SNL MWL 07

"Notice of Disapproval: Monitoring Well Plug and Abandonment Plan and Replacement Well Construction Plan, Decommissioning of Groundwater Monitoring Well MWL-BW1, Installation of Replacement Groundwater Monitoring Well MWL-BW2, April 9, 2007"

**Monitoring Well Plug and Abandonment Plan
and
Replacement Well Construction Plan**

**Decommissioning of
Groundwater Monitoring Well MWL-BW1**

Figure 1
Location of MWL-BW1 and
Proposed Well MWL-BW2

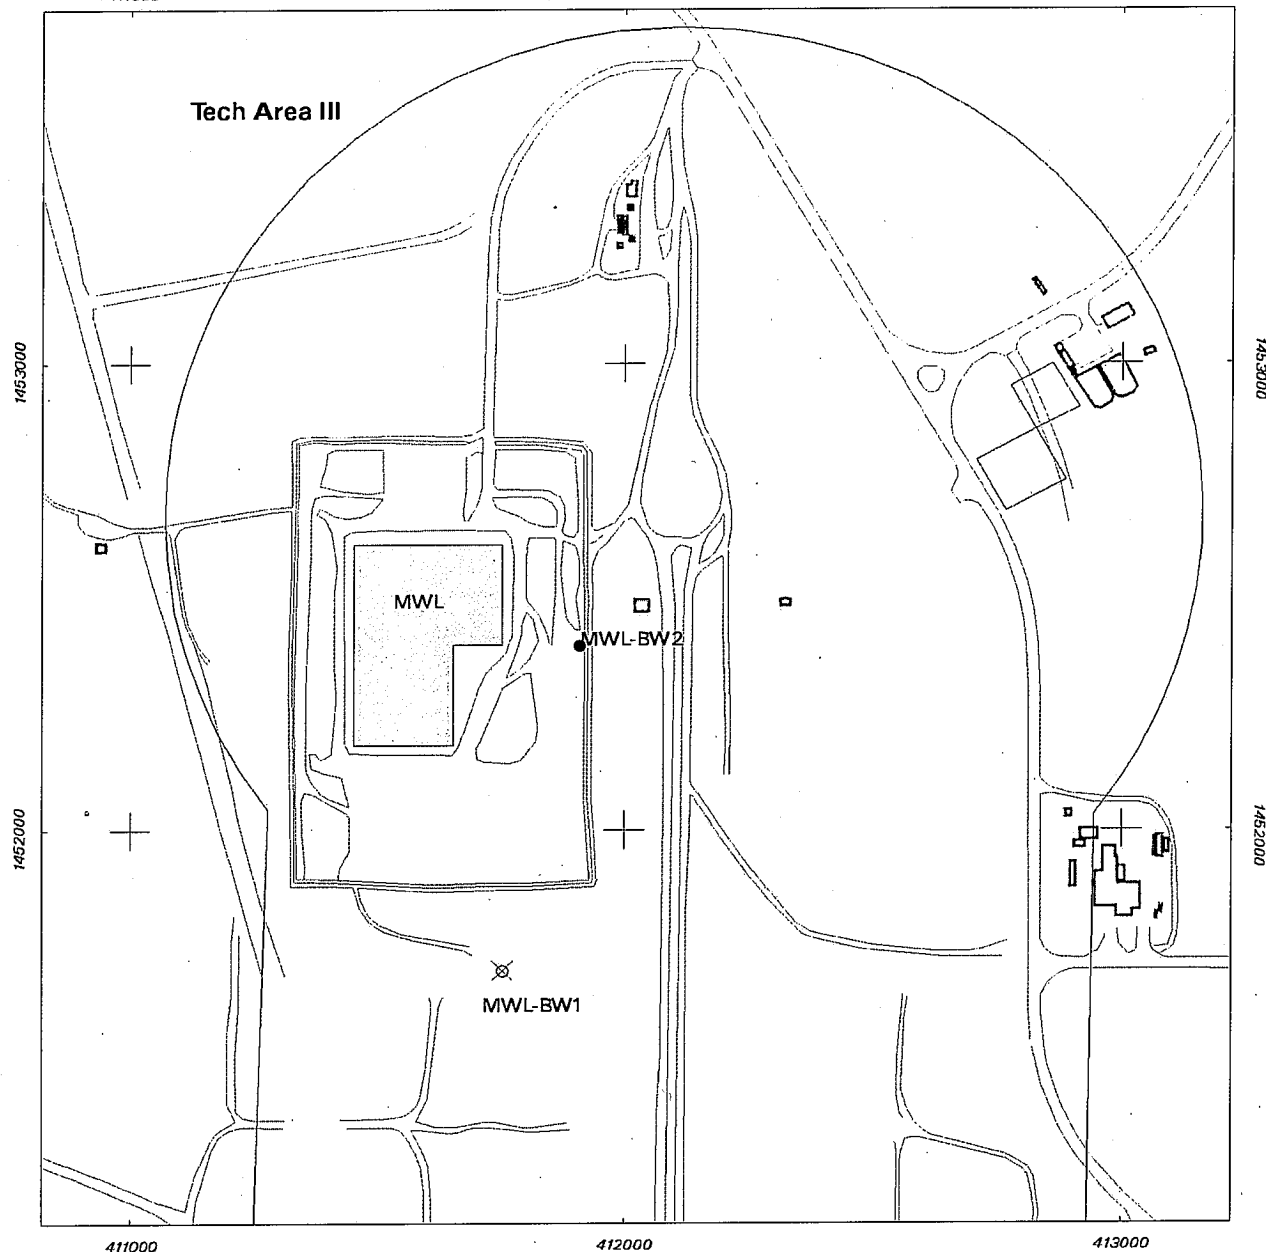
2. Page 5, Section 5.1 – this section states that MWL-BW2 will be installed a minimum of 25 feet away from the existing well (MWL-BW1) location. Later, the text states that MWL-BW2 will be located about 700 feet northeast of MWL-BW1, but that the actual location will be selected with concurrence from NMED. The proposed location for MWL-BW2 as shown on Figure 1 is acceptable to the NMED. A location about 200 feet east of the Mixed Waste Landfill (MWL) should be sufficient. Modify the plan to more precisely indicate the location of proposed well MWL-BW2.

Response: This section of the plan has been clarified and now reads: "MWL-BW2 will be installed at a location approximately 710 ft northeast of MWL-BW1, and approximately 140 ft east of the MWL (Figure 1)." Also, please note that the proposed location for MWL-BW2 has been adjusted slightly to the north from the location shown in the original Figure 1. The new proposed location is now due east of the center of the MWL footprint.
